Questions and Answers

The clip below is from the functional drawing T6.03 and shows the connection from the microphone logic cables to a Biamp Logic-Box in a typical courtroom:

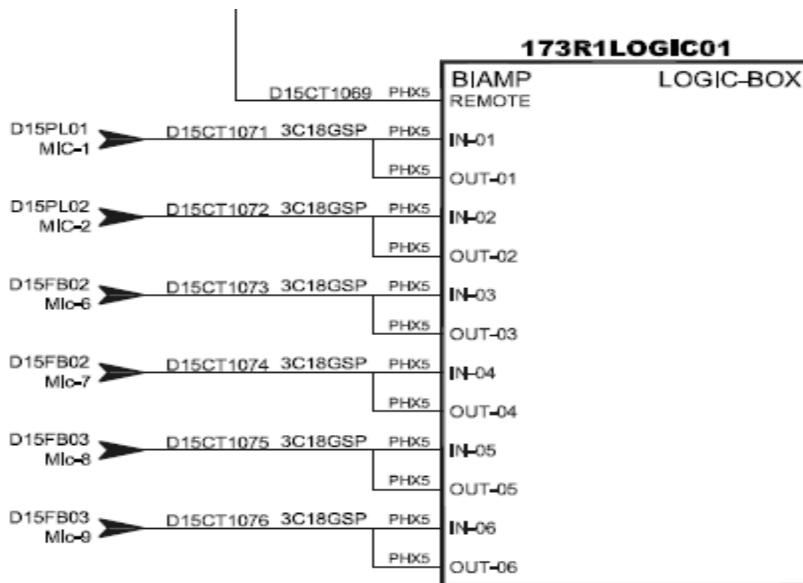
Question 2: It appears that I see some desired functionalities within the RFP - that the current equipment and system design cannot accommodate. (IE; The muting of the microphones via the Crestron Control system.) (We can mute the microphones at the mixer - but cannot control the microphone's switch.) My question is that this RFP is for programming and other work required to make these systems work properly and work well. There is not to be any supply of any equipment. Any additional equipment needed is to be an additional cost item (?) And/or anywhere that the RFP's desired functionality exceeds the ability of the existing systems - we will ask Mr. Safer to clarify (?) And that any work modifying the systems to better accommodate functionalities that were not originally designed into these systems would be additional item (?)

Response: Proposals should include all labor and equipment required to provide the functionality expressed in the RFP. Additional equipment is to be included in the firm, fixed price. See below regarding the muting of microphones.

The currently installed hardware, as shown on the functional drawings provided, has the capability to have the mute buttons on the courtroom microphone bases control the Biamp Audio mute control and send status to the light on the microphone base. DIP switches within the microphone base will need to be set appropriately, if not already set. See the following application note:
